UNITED STATES PATENT AND TRADEMARK OFFICE

APPLICATION NO.	FILING DATE	FIRST NAMED INVENTOR	ATTORNEY DOCKET NO.	CONFIRMATION NO.
10/661,494	09/15/2003	Howard E. Rhodes	M4065.0087/P087-A	7413
24998	7590	11/12/2009	EXAMINER	
DICKSTEIN SHAPIRO LLP 1825 EYE STREET NW Washington, DC 20006-5403			BERARDESCA, PAUL M	
			ART UNIT	PAPER NUMBER
			2622	
			MAIL DATE	DELIVERY MODE
			11/12/2009	PAPER

## **DETAILED ACTION**

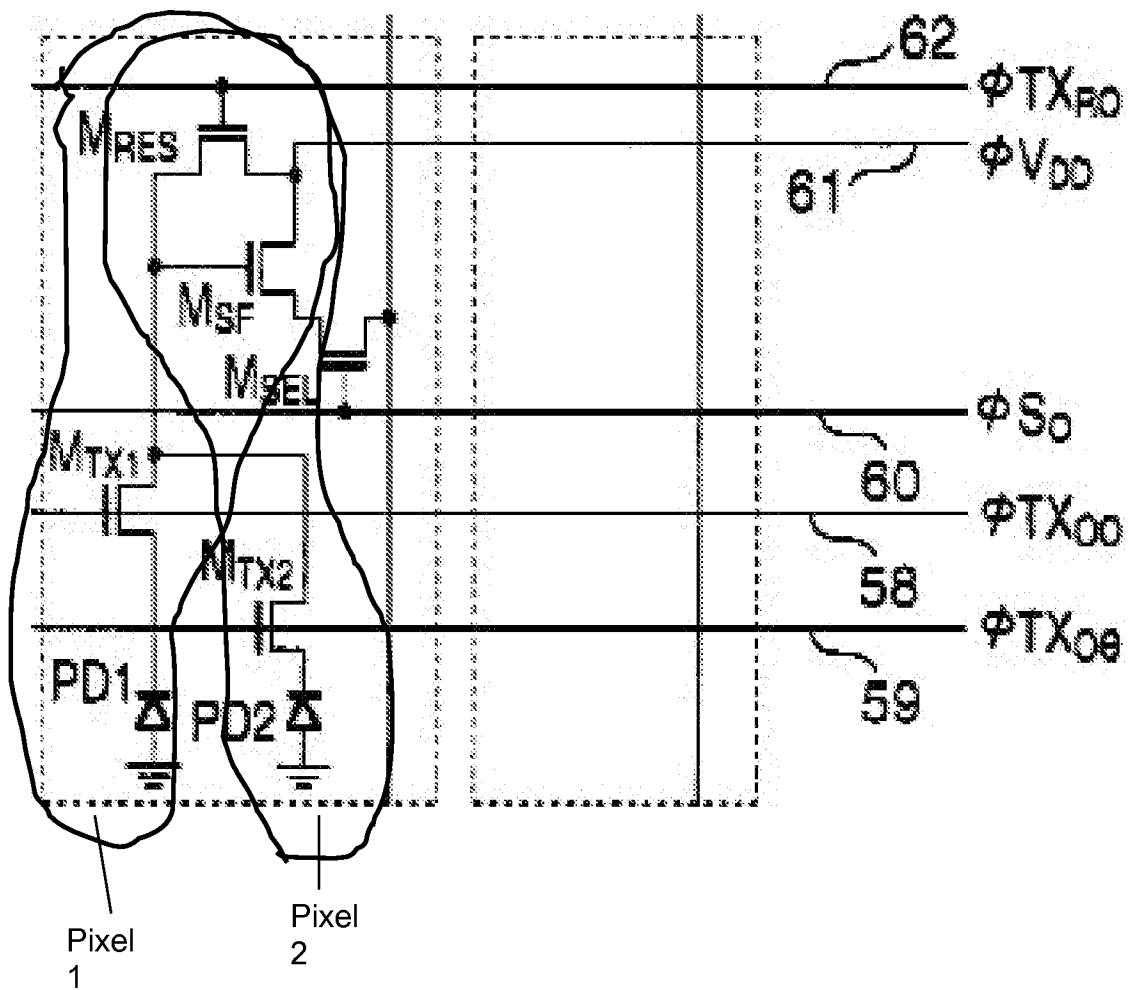
PD2) respectively, is provided to the column output line 57. The claim only requires that the row select lines, when activated, connect the associated one of the first and second pixels with the shared column. Figure 10 of Hashimoto is reproduced below to show what is interpreted as the first and second pixels.

Although pixels 1 and 2 share an amplifier, they have exclusive components, which makes them two separate entities. When TX0o is activated, the charge from PD1 is transferred to the gate of the source follower, where it is amplified and then

transferred from the output of the source follower (output of Pixel 1) directly to the column line 57 since transistor Msel is always turned on when TXoo is on. Similarly, when TXoe is activated, the charge from PD2 is transferred to the gate of the source follower, where it is amplified and then transferred from the output of the source follower (output of Pixel 2) directly to the column line 57. Therefore, 58 and 59 do in fact cause an amplified pixel signal to be output. For these reasons, select lines 58 and 59 read on claimed "first row select line" and "second row select line" respectively.

where it connects the first pixel and the second pixel with respect to the column line" as broadly claimed. Shown below is a reproduced Bird figure 5 showing how the active area can be considered diagonal where it connects the two pixels.

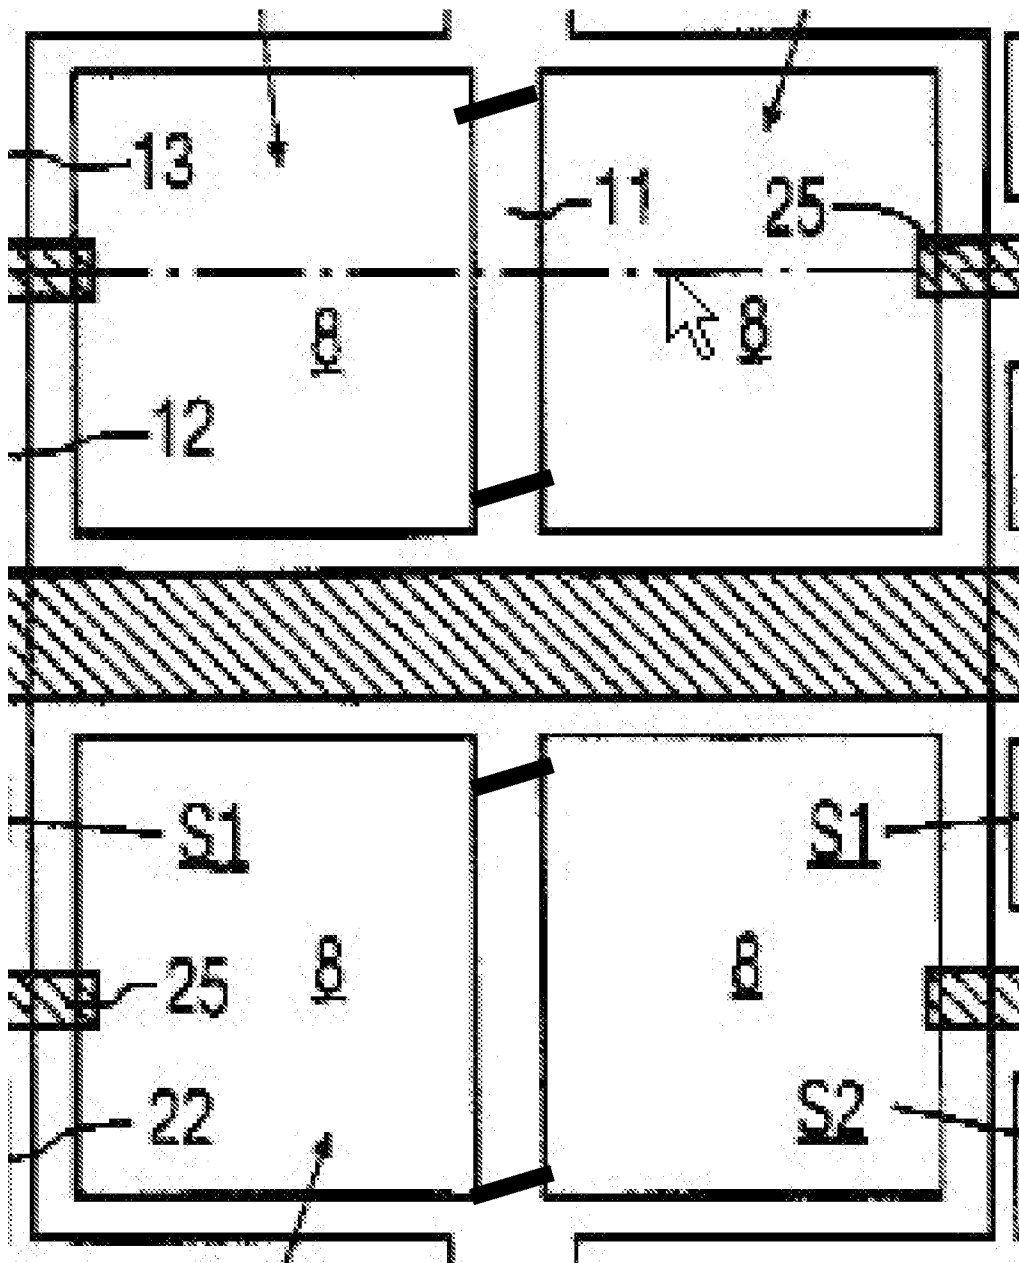
Applicant's arguments with respect to claim 97 have been fully considered but they are not persuasive. Applicant argues that "None of the cited references discloses this diagonal aspect of the connecting/shared active area in relation to the column line...In Bird, all active areas are at parallel and orthogonal angles relative to the column conductor (e.g., 11 of Fig. 5)." The examiner cannot agree. When the term "diagonal" is used as an adjective it defines a direction and not a shape. To say that an active area component is in a diagonal direction with respect to the column line does not limit the active area component to be in the shape of a diagonal line with respect to the column line, and therefore does not distinguish from any other active area component connecting the two pixels. Specifically, the active area can be interpreted to be in a diagonal direction anywhere. In other words, a diagonal line can be drawn anywhere from one pixel to the other across the shared active area and therefore it is "diagonal
